**NOTICE OF MEETING
ZONING BOARD OF ADJUSTMENT
OF THE CITY OF GALVESTON
WEDNESDAY, APRIL 9, 2025 - 3:30 PM
REGULAR MEETING
City Council Chambers, 2nd Floor of City Hall
823 Rosenberg, Galveston, Texas**

8.A **25Z-004 (8819 Stewart Road)** Request for a variance from the Galveston Land Development Regulations, Article 10, Height and Density Development Zone regarding Build-to-Line and Wall Plane Articulation. Property is legally described as Hall & Jones Survey, Lot B, Chauhan Subdivision (2007), in the City and County of Galveston, Texas. Applicant: Rafiq Ali, Catalyst Technical Group, Incorporated
Property Owner: Harold Smart, Vrone Hospitality, LLC on behalf of OKG LLC

8.B **25Z-005 (1721 Postoffice / Avenue E)** Request to appeal the City of Galveston Landmark Commission's decision regarding case 25LC-002: Request for a Certificate of Appropriateness for modifications to the structure including use of an alternative material, replacement of existing windows, and addition of covered porch to the rear façade. The property is legally described as Abstract 628 M.B. Menard Survey, Lot 2 & West 10-8.5 Feet of Lot 3, Block 437, in the City and County of Galveston, Texas.
Applicant: R

3 EXTERIOR ELEVATION - REAR VIEW
 SCALE: 1/4" = 1'-0"

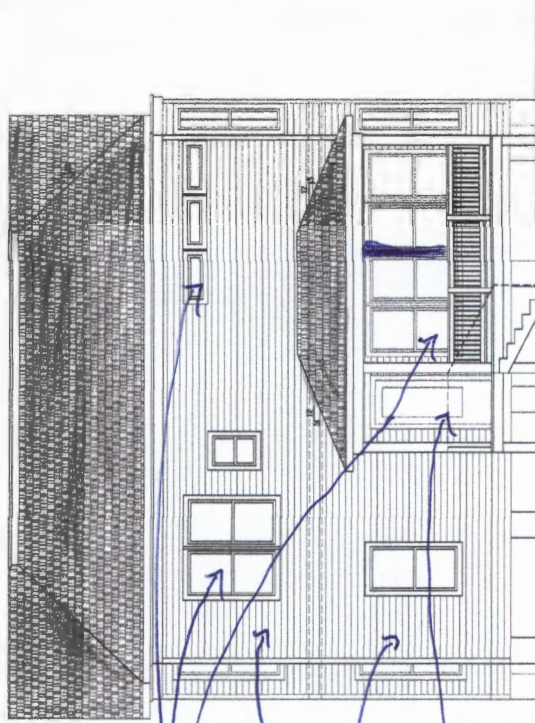
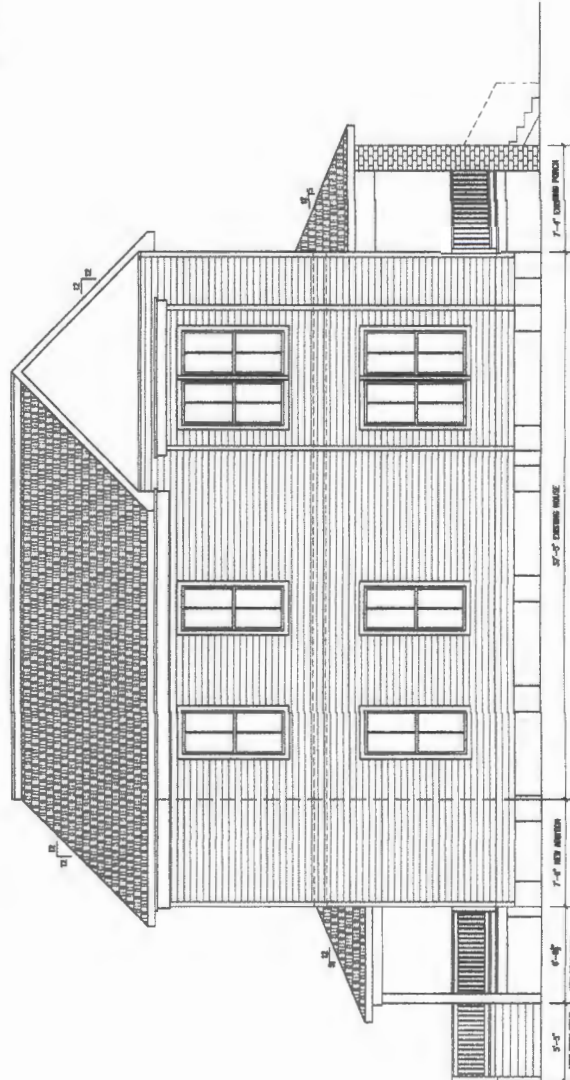
Replaced with
Atrium Windows

Replaced with
Hardy Plank

Replace with 5/8
glass door from
original house

Added Porch AND Porch Roof
 Replaced rotted back wall with new wall + windows

1. The exterior modifications shall conform to the design, materials and placement presented in Attachment A of the staff report with the following modifications:
 - a. The cementitious siding be removed and replaced with wood siding to match the existing wood siding elsewhere on the house;

- b. Replacement vinyl-clad windows added into existing openings be replaced with wood windows that closely match the original windows as closely as possible, except when those windows reflect interior changes to the floor plans;
- c. The rear porch handrails shall be of the typical “simple, square” design;
- d. The applicant complete all required work by August 3, 2025;

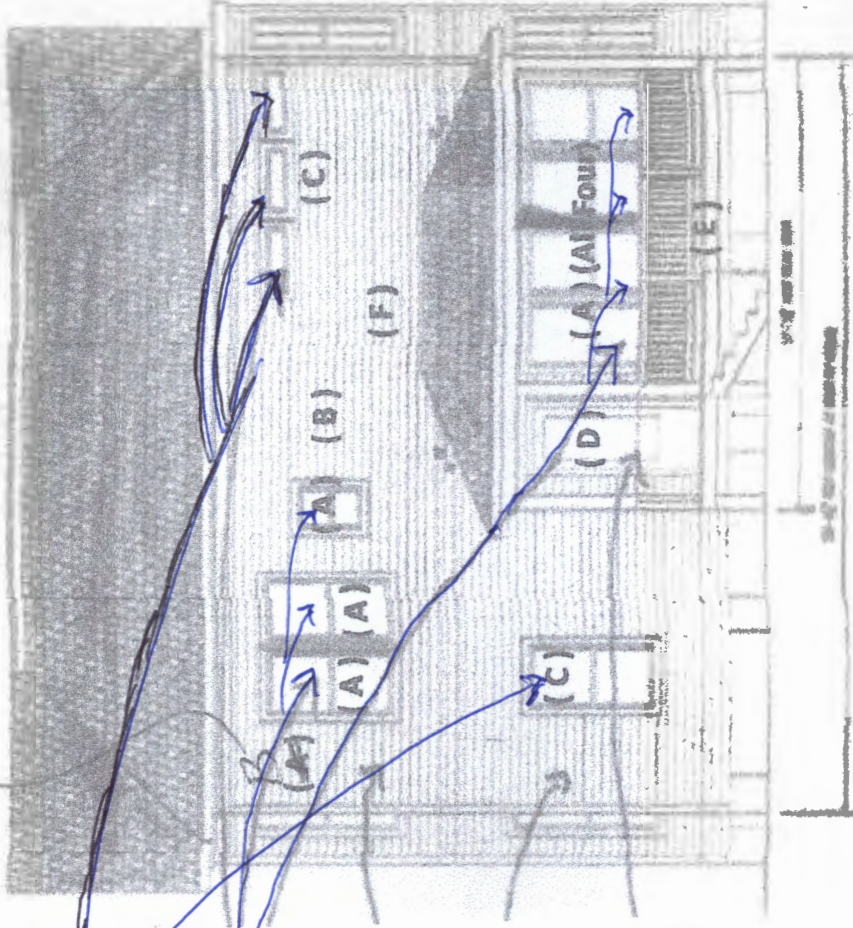
All rear rooms have interior changes and only 4 windows were approved and 7 were not approved.

We feel like all windows should be approved instead of having a "patchwork "of different windows.

Why would only 4 windows be approved when all are new interior design and new uses?

3 EXTERIOR ELEVATION - REAR VIEW
SCALE 1/4" = 1'-0"

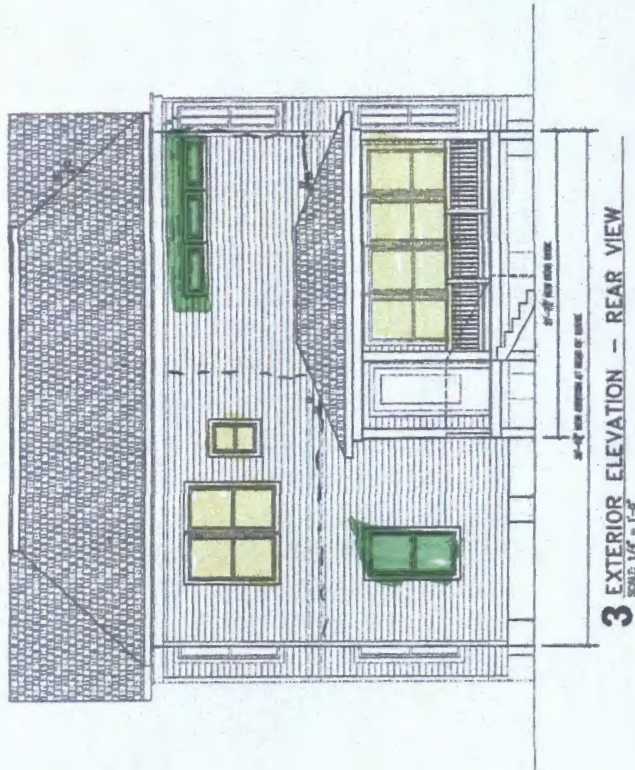
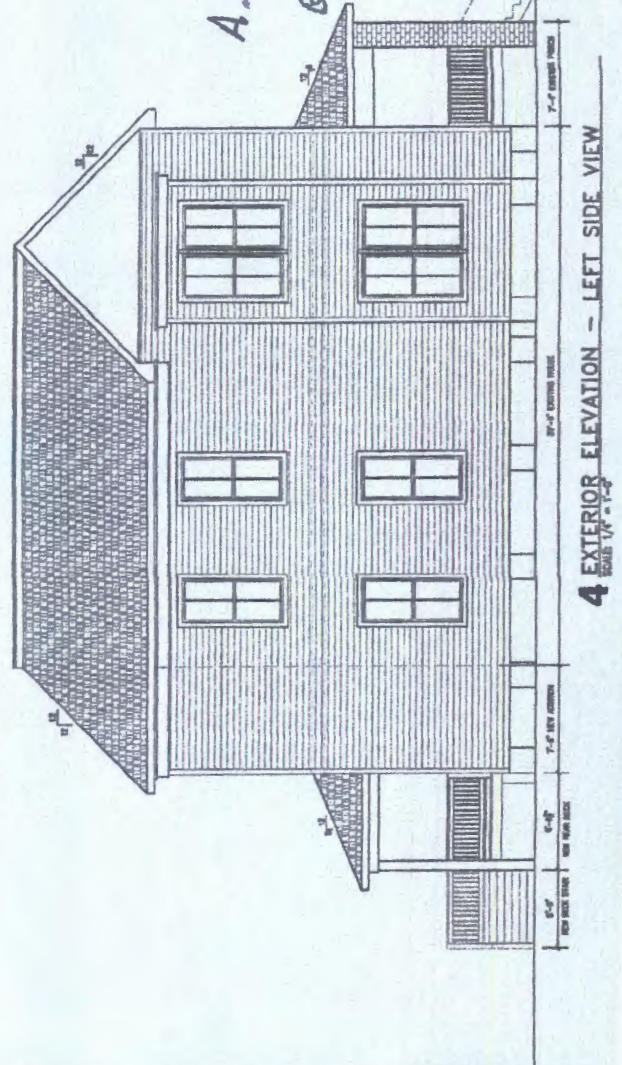
These were all new openings
with new windows
All four rooms have new uses

APPROVED

REJECTED

1 FLOOR PLAN - LEVEL 1
 SCALE: 1/8" = 1'-0"

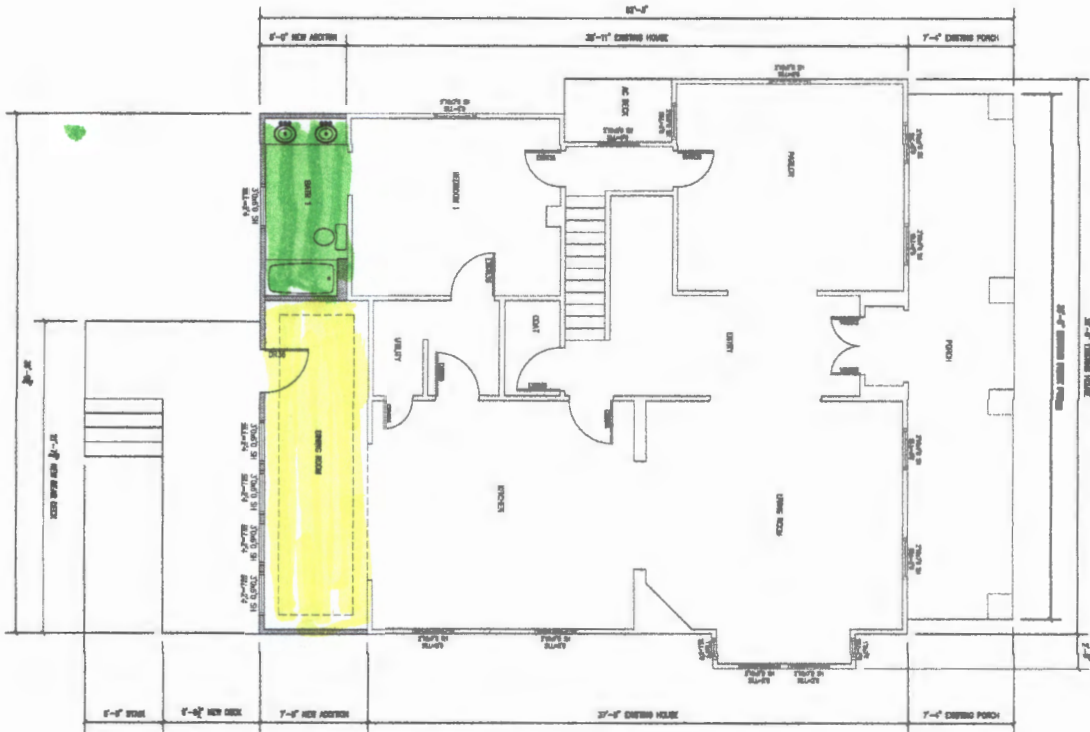
- A. Restore window openings and 2 1/2 wood windows
- B. Previous windows can remain covered

C. New windows in new openings can remain.
